Our Ref: 218345_LEO_001B.docx

DA2018/41 – DAROOBALGIE LANDFILL EXPANSION

We refer to the letter from the NSW Environment Protection Authority (EPA) dated 26 November 2018 in relation to the proposed expansion of the Daroobalgie Waste Management Facility and provide below responses to the additional information request listed in Attachment A of that letter. A headline of each additional information request is included in italics and the EPA letter is provided as **Attachment A** to this response to cross-reference the detailed request.

DEVELOPMENT APPLICATION DA2018/41 – STOP THE CLOCK

DRAWING		LANDFILL CELL SUBGRADE AND LEACHATE DRAINAGE SYSTEM STAGE 4A1	
PROJECT NUMBER 213141	DRAWING FILE 213141_07G_C014-C015.dwg	ORIGINAL	A1
SURVEY MARK	R.L.	DATUM	A.H.D.
IMAGE SOURCE		SET	07
STATUS FOR REVIEW	SHEET C014 OF C015

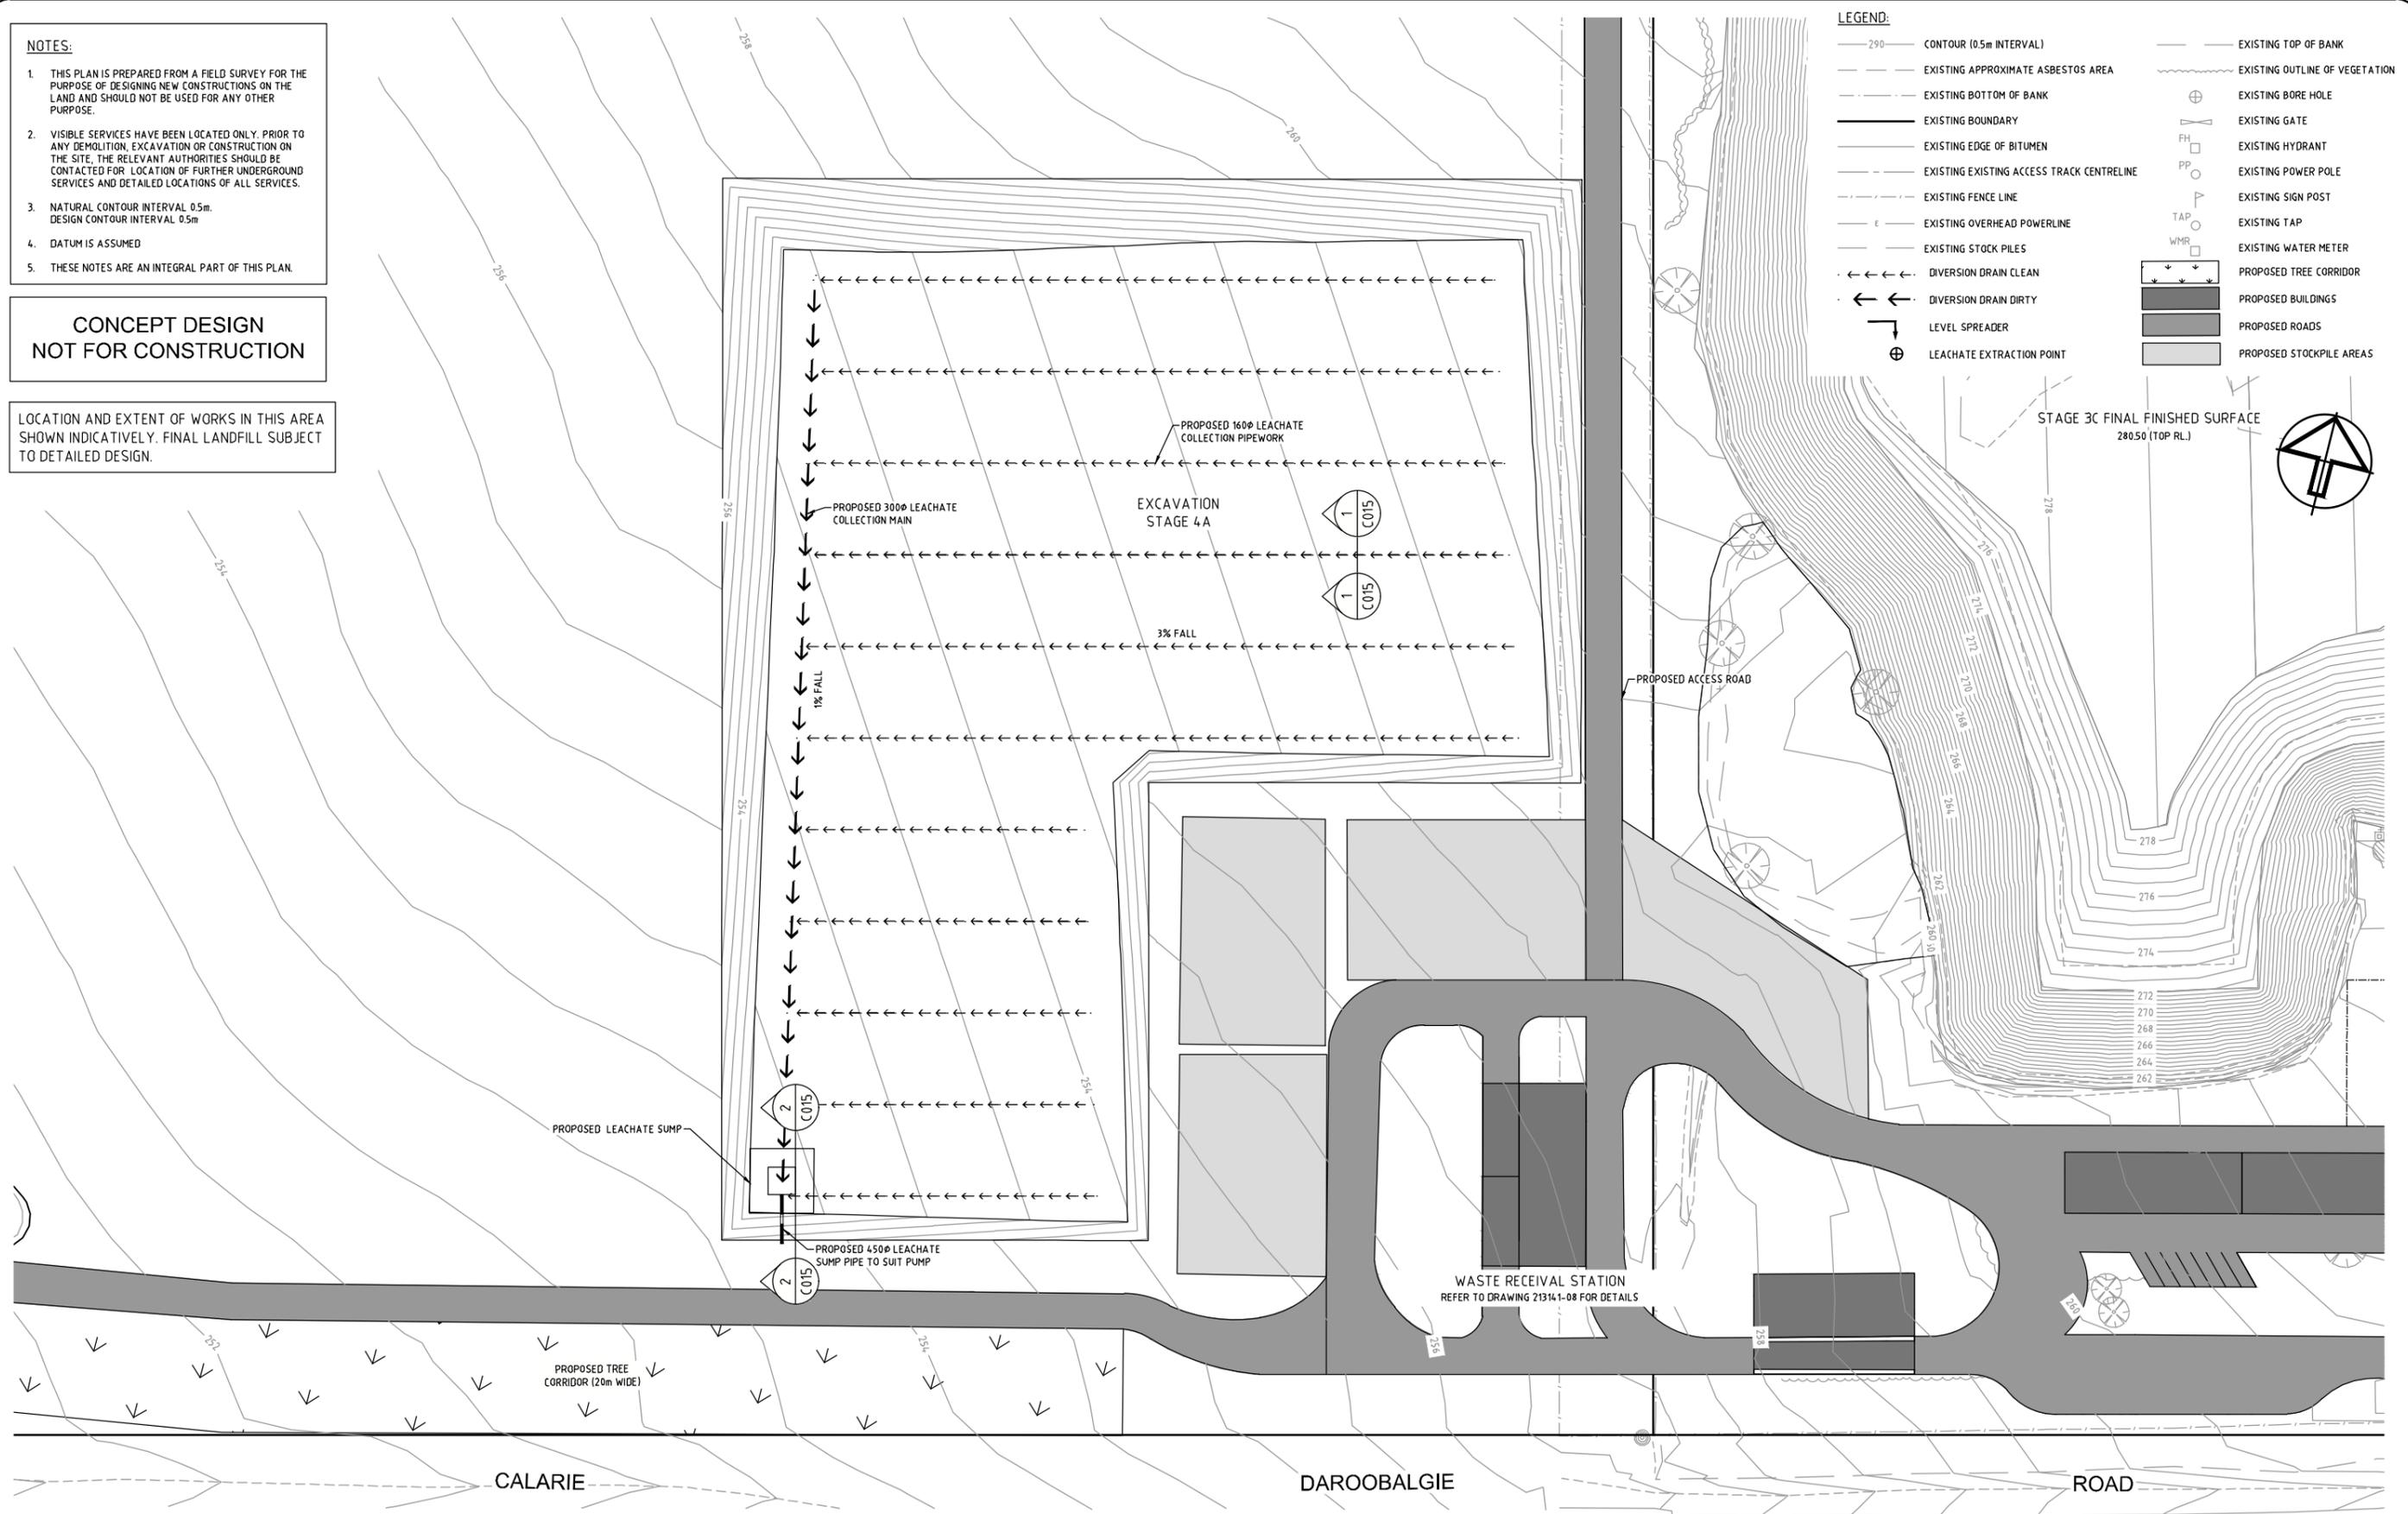
The EPA notes that a 450 mm diameter leachate extraction riser and sidewall lining is proposed, this is acceptable, notwithstanding that the EPA requests additional information. The EPA requests concept drawings, plans and cross-sections, depicting the riser and layout of the leachate collection system for the first stage of the proposed expansion.

Concept drawings for the proposed leachate extraction pipe in Stage 4A are included as **Attachment B**. All conceptual details are subject to final detailed engineering design.
